[Docket No. FAA-2023-0668; Project Identifier AD-2023-00199-R; Amendment 39-22453; AD 2023-11-07]

Airworthiness Directives; Various Helicopters

Final rule; request for comments.

Figure 1 to paragraph (g)(1)(i)— *Fundamental Effective Isotropic PSD at Outside Interface of Rotorcraft Antenna*

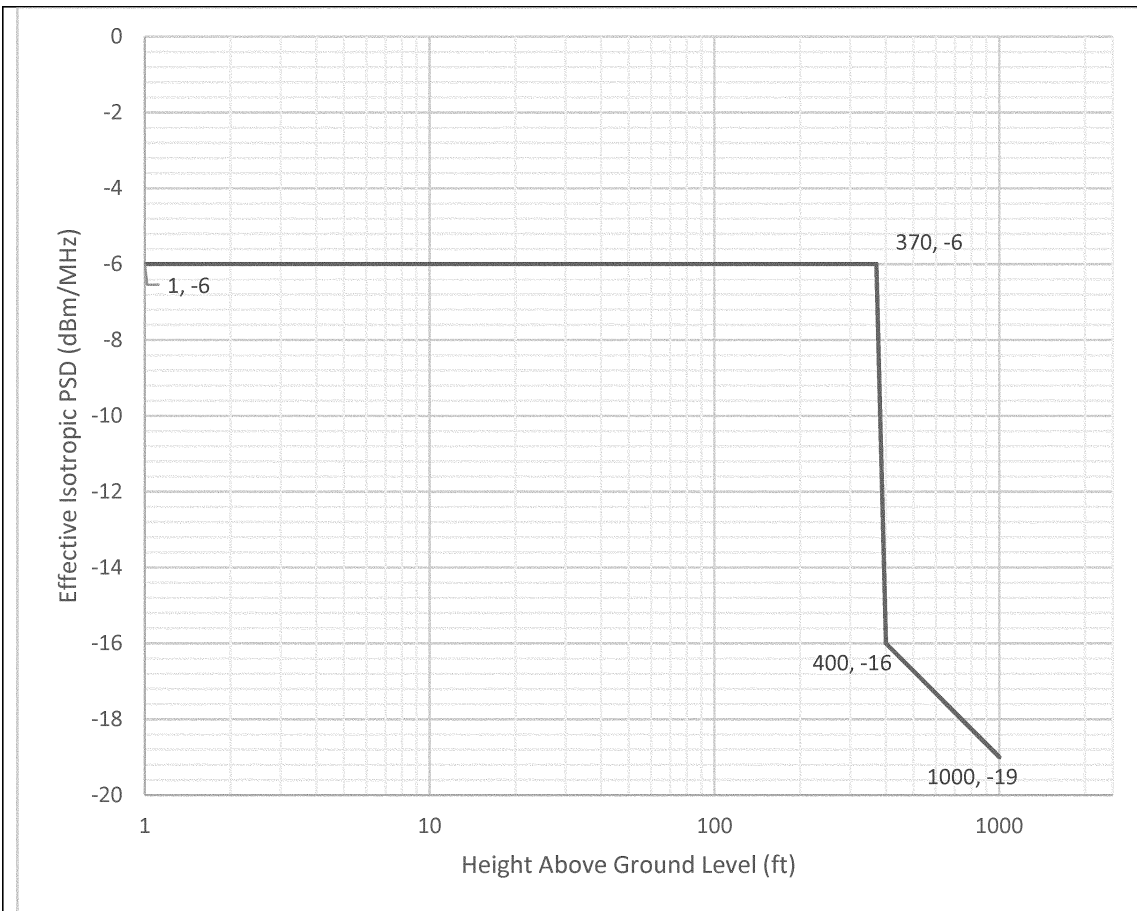
Comment summary: Thales and Sikorsky requested the FAA clarify several aspects of the PSD curve in figure 1 to paragraph (g)(1) of the proposed AD: whether no elevation mask is taken into account at and below 350 feet above ground level (AGL); at which base station emission power the PSD curve corresponds (62 dBm/MHz or 65 dBm/MHz); and whether the radio altimeter performance criteria in the curve explicitly covers any 5G emitter station up to 65dBm/MHz in the applicable 3.7–3.98 GHz band, for the foreseeable future. Sikorsky requested that the FAA revise the proposed AD to include a PSD curve that reflects the reduced EIRP levels for helicopters operating at the 188 priority airports (5G CMAs) with reduced power levels.

Comment summary: Sikorsky requested the FAA revise the PSD curve in figure 1 to paragraph (g)(1) of the proposed AD to change the height above ground at -6 dBm/MHz from 270 feet to 370 feet, and at -16 dBm/MHz from 300 feet to 400 feet. Sikorsky stated its request was based on several factors, including the minimum safe obstacle avoidance distance and the typical decision height used for radio altimeter critical operations associated with missed approach points (MAPs) during point in space (PINS) approaches. Sikorsky further stated that radio altimeters are not operationally used above 1000 feet, and therefore there is little value for any PSD restrictions above 1000 feet operationally.

FAA response: The notch in the PSD curve does not mean that no elevation mask is taken into account below 350 feet AGL. The elevation mask is taken into consideration below 350 feet AGL and is a fundamental consideration in how the PSD curve was established. The PSD curve was calibrated to cover 5G C-Band emitter stations up to 65 dBm/MHz in the applicable 3.7–3.98 GHz band.

The FAA disagrees with revising the AD to include a PSD curve for helicopters operating at airports with reduced power levels. The radio altimeter tolerant rotorcraft PSD curve was established to provide safe operation anywhere in the contiguous U.S. regardless of whether a helicopter is operating at a 5G CMA.

FAA response: The FAA assumed an emitter base station height of 350 feet based on consensus reached in rotorcraft industry group meetings. Additionally, FAA analysis of existing emitter base station height data shows that, while higher emitters do exist, they are infrequently adjacent to helipads. Second, the FAA assumed the rotorcraft was no closer than 50 feet above and 75 feet laterally from the emitter. The vertical distance was based on pilot feedback and the lateral distance was based on common lateral separation from the main rotor tip recommendations of 2 main rotor diameters from the tip of the rotor, selecting a 30 foot rotor as the smallest rotor in this class of aircraft with the antenna under the main rotor mast. An operator of an individual model rotorcraft with a larger rotor diameter may request approval of an AMOC to the AD on the basis of separation distance. Third, the FAA assumed that the emitter was active at the full rural power level of 65 dBm/MHz allowed in FCC Report and Order FCC 20–22.^[2] The FAA then evaluated the resulting curve against data from radio altimeters and found it to be achievable with current technology using filters that have been developed. Based on data from existing emitters, if the height reduction from 370 feet to 270 feet, as requested by the commenter, were adopted, it would result in many more landing scenarios unprotected from

interference because emitters on towers at about 250 feet as opposed to the accepted assumption of 350 feet are much more common. For this reason, the FAA did not adopt this request.

The FAA has re-evaluated the need for PSD performance requirements above 1000 feet and agrees with the reasons provided by the commenter. The PSD curves specified in this AD have been changed accordingly.

Figure 2 to paragraph (g)(1)(ii): *Spurious Effective Isotropic PSD at Outside Interface of Rotorcraft Antenna*

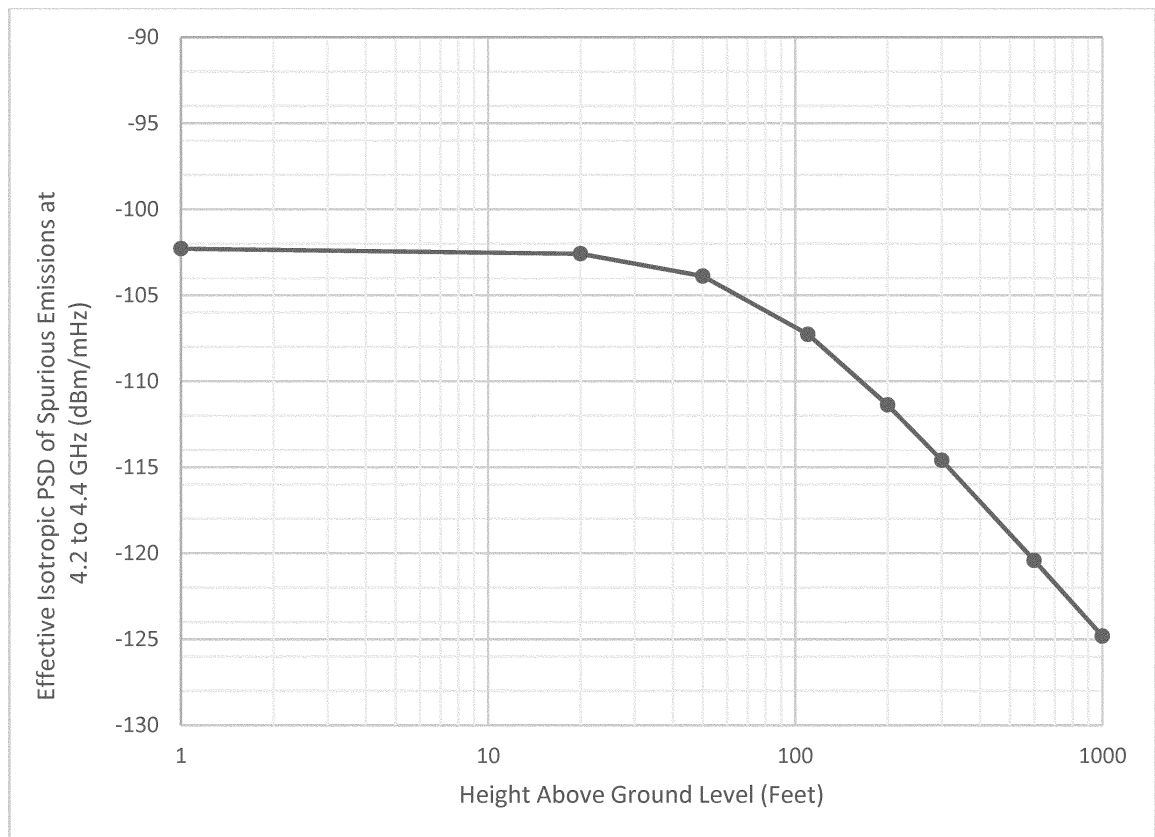
As a result, the FAA is requesting comments on the spurious PSD tolerance curve in figure 2 to paragraph (g)(1)(ii) of this AD.

Comment summary: HAI, Sikorsky, and Thales requested that the FAA revise the proposed AD to include the frequency range to which the PSD tolerance curve thresholds apply, a new figure indicating the spurious tolerance similar to the figure with the PSD tolerance curve, and a specification of the altitude dependence for spurious tolerance.

In this final rule, the FAA replaced the proposed fixed aggregate spurious emission level of -42 dBm/MHz (conducted) with a spurious PSD tolerance curve for 5G C-Band interference from a single base station. This form of the requirement is consistent with the transport and commuter category airplane requirement. Similarly, it does not include an aggregation factor or any base station or aircraft antenna gain factors. The spurious PSD tolerance curve is based on a different spurious emission level than what the FAA proposed in the NPRM (-30 dBm/MHz conducted for a single indoor base station instead of -48 dBm/MHz conducted for a single outdoor base station and an aggregation factor of 6 dB which yielded an effective aggregate level of -42 dBm/MHz).

FAA response: The FAA agrees and has added the frequency range to the PSD tolerance curve. Additionally, as explained previously under “Actions Since the NPRM Was Issued,” the FAA has replaced the proposed fixed emission level with a spurious PSD tolerance curve.
